CITY PLAN COMMISSION**THURSDAY, OCTOBER 6, 2022****FILE NUMBER:** S212-329**SENIOR PLANNER:** Mohammad H. Bordbar**LOCATION:** Lupo Drive at Vicksburg Street, northwest corner**DATE FILED:** September 7, 2022**ZONING:** IR**CITY COUNCIL DISTRICT:** 6 **SIZE OF REQUEST:** 0.950-acres**MAPSCO:** 34W**APPLICANT/OWNER:** Oncor

REQUEST: An application to replat a 0.950-acre tract of land containing all of Lots 1 through 6 in City Block 6/8570 to create one lot on property located on Lupo Drive at Vicksburg Street, northwest corner.

PRELIMINARY PLAT
ONCOR LUPO
LOT 1A, BLOCK 6/8570

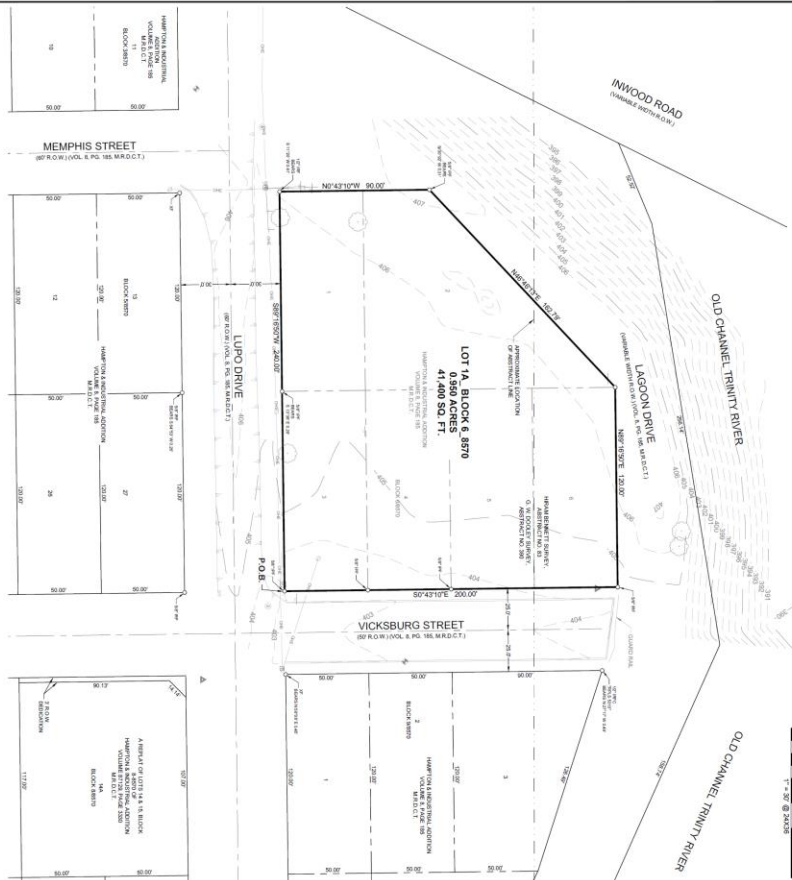
7. On the final plat, include two boundary corners tagged with these coordinates: "Texas State Plane Coordinate System, North Central Zone, North American Datum of 1983 on Grid Coordinate values, No Scale and no Projection."

15. On the final plat, dedicate 28 feet of right-of-way (via fee simple or street easement) from the established centerline of Vicksburg Street. Sections 51A-8.602(c), 51A-8.604(c) and 51A-8.611(c).
16. On the final plat, dedicate a minimum 5-foot by 5-foot corner clip (via fee simple or street easement) at the intersection of Lupo Drive and Vicksburg Street. Section 51A 8.602(d)(1)
17. Prior to final plat, a larger corner clip may be requested during engineering plan and traffic review to accommodate an adequate turning radius, or to maintain public/traffic appurtenances, within the area of the corner clip. Section 51A 8.602(d)(1), 51A 8.608(a)

18. On the final plat, determine the 100-year water surface elevation across this addition.
19. On the final plat, dedicate floodway easement, floodway management area or floodway easement (within common area), with the appropriate easement statement included on the face of the Plat. 51A 8.611(d); DWU Floodplain Management; Drainage Design Manual Addendum V

21. On the final plat, specify minimum fill and minimum finished floor elevations. *Section 51A-8.611(d), Trinity Watershed Management.*
22. On the final plat, show the natural channel set back from the crest of the natural channel. *Section 51A-8.611(d), Trinity Watershed Management.*

29. On the final plat, identify the property as Lot 1A in City Block 6/8570. Ordinance 1A, Page 131 pages 131-148, Section 2 (passed August 13, 1872).
